文件编号 Document No.	PCN-AXK20210710-01	文件名称 Document Name	产品/工艺变更通知 Product/Process Change Notice(PCN)
文件版本 Document Version	中文/A1	保存期限 Retention Period	3年 3 years

主题：关于 ESP-12H 模组底部丝印变更的 PCN

PCN 编号 PCN No.	AXK20210710-01	提出日期 Issue Date of PCN	2021-7-10
产品名称 Product Name	WIFI 模组 ESP-12H	变更日期 Proposed Date of Change	2021-7-10
封装类型 Package Type	SMT	首次出货日期 Proposed Date of First Shipment	2020-12-1

变更前图片/Before change picture 变更后图片/After change picture

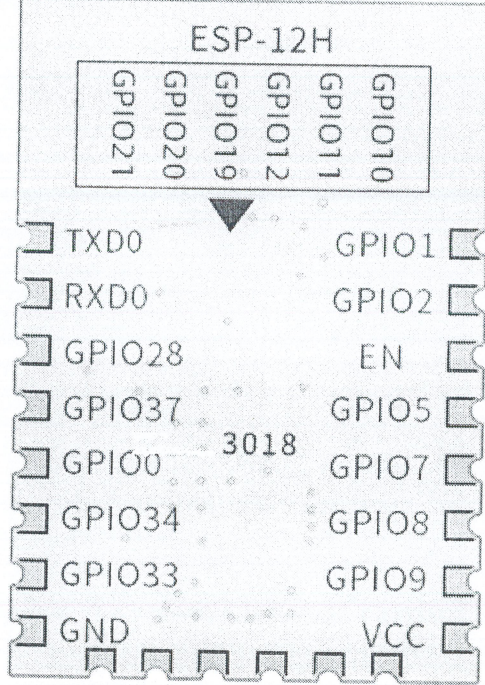
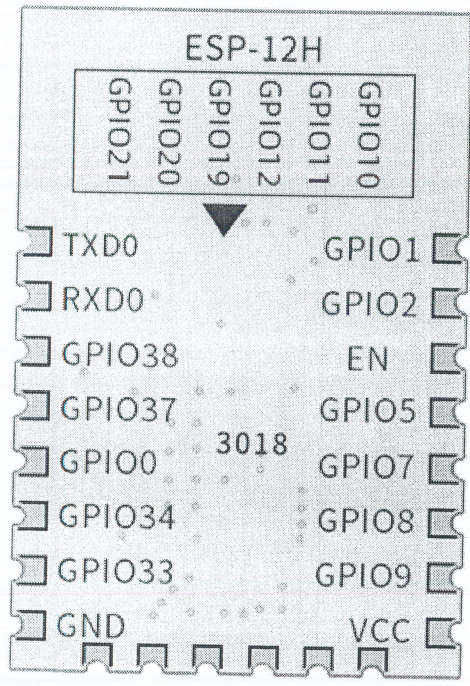
变更原因/Reason for Change:
 模组底部 1 个 IO 口引脚丝印错误

变更描述/Description of Change:
 模组底部第 20 pin 脚 IO 口引脚丝印错误, 实际对应主芯片的 GPIO 38。现更新模组丝印, 修正 pin 脚描述。

变更识别方式/ Change Identification Method:

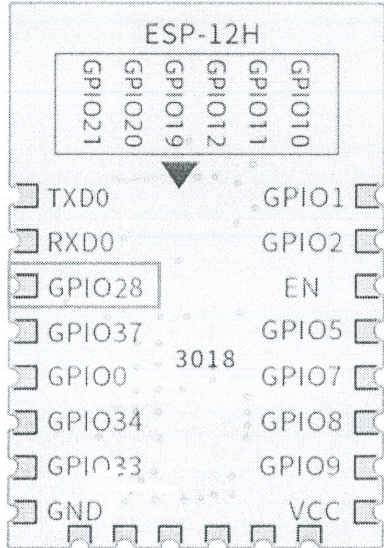
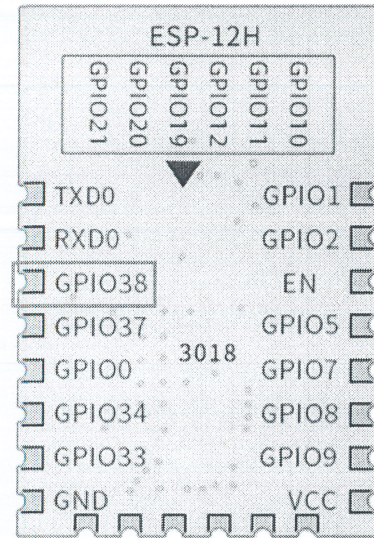
变更前：模组第 20 个 pin 脚丝印是 GPIO28
 Before change:

变更后：模组第 20 个 pin 脚丝印是 GPIO38
 After change:
